TITLE: PC 15-21; 611 E. Butterfield Road – Sam's Club

MEMORANDUM

SUBJECT: PC 15-21; 611 E. Butterfield Road – Sam's Club

1. *Building Height*

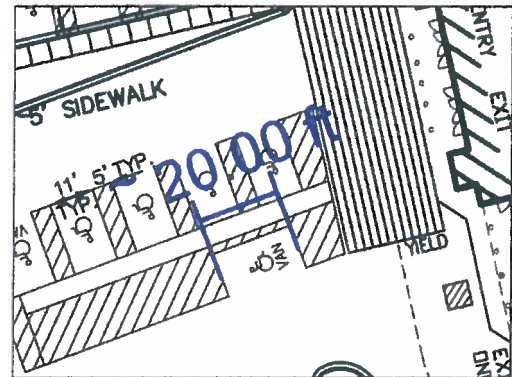
Pursuant to Section 155.415 (G) of the Lombard Zoning Ordinance, the petitioner requests a deviation to increase the maximum permitted building height from thirty-feet (30') to thirty-five feet and four inches (35'4"). Staff can support the requested deviation as the majority of the height of the structure beyond thirty feet (30') appears to be a parapet wall, which is not

traditionally included in the overall measured height of a structure. However, the relief request was published for the most extreme situation due to ongoing engineering analysis that may result in changes in final grading from which the building height is measured. In this scenario, staff supports the requested deviation and finds that the proposed deviation would not adversely impact the value or use of any other property, especially in consideration that the building heights of the surrounding structures exceed the proposed height of the Sam's Club.

3. *Loading*

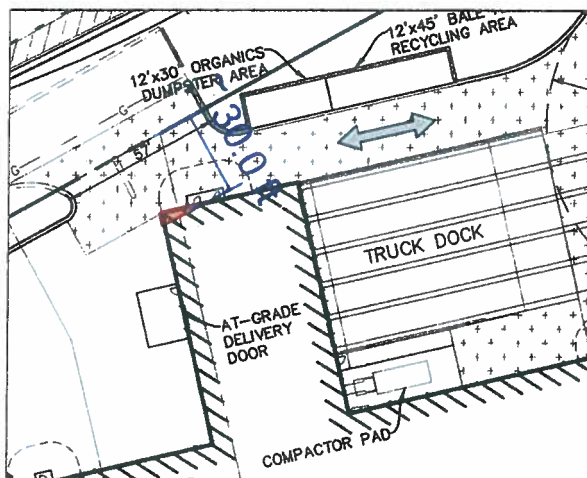
- a. Pursuant to Section 155.603 (A)(1) of the Lombard Zoning Ordinance, the petitioner requests a deviation to not fully screen loading berths from adjacent property in an O Office District. In their response to standards, the petitioner states that there will be extensive landscaping and a screen wall in areas adjacent to Embassy Suites to the east. However, this screening is only practical at the first floor level. The overall height of the

Staff can support the requested deviation based on the reasons outlined by the petitioner and agrees that it is impractical to assume that the loading docks can be blocked from view of the upper stories of Embassy Suites.
